UNITED STATES ENVIRONMENTAL PROTECTION AGENCY
REGION I
JOHN F. KENNEDY FEDERAL BUILDING (HBT)
BOSTON, MASSACHUSETTS 02203-2211

N60087.AR.000759
NAS BRUNSWICK
5090.3a

8 February 1999

Monitoring Event 12 Final Report for Site 9 at Naval Air Station, Brunswick, Maine

NAS Brunswick Site 9 Groundwater Elevation Data

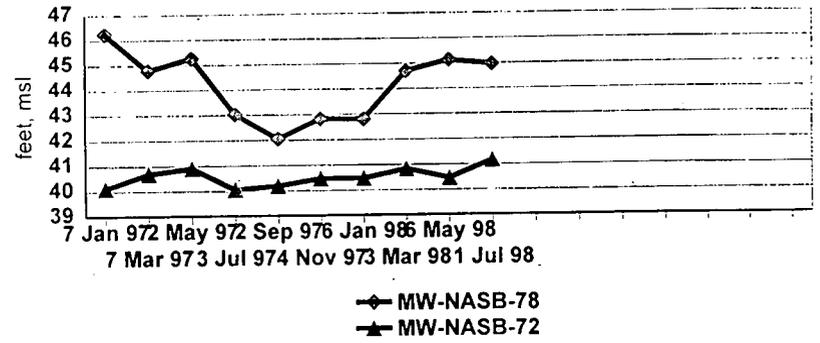
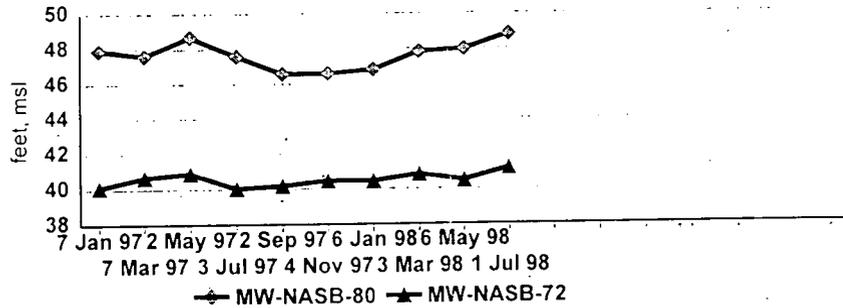
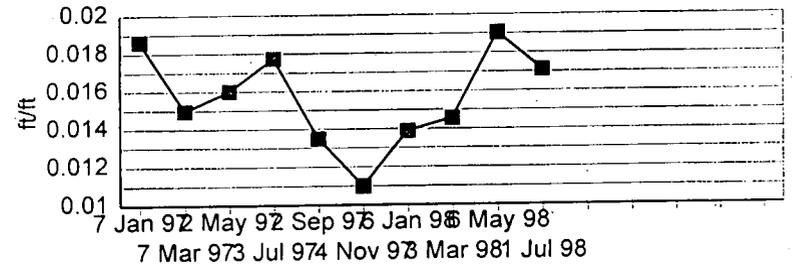
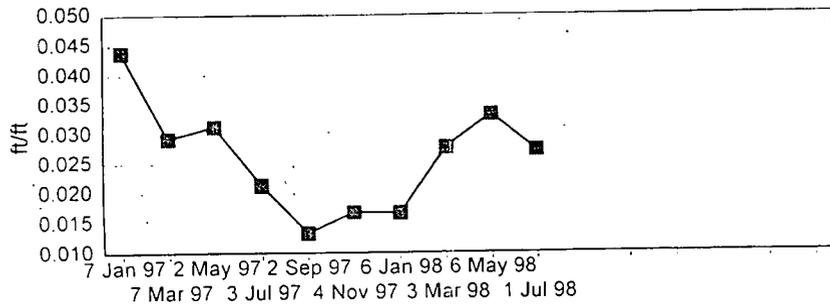
4. In 1998, it appears the groundwater gradient might be increasing to it's historical level across the site prior to construction of the retention ponds in late 1996. Elevations of most wells are rising slightly in response to the ponds. Please see enclosed charts for your information.
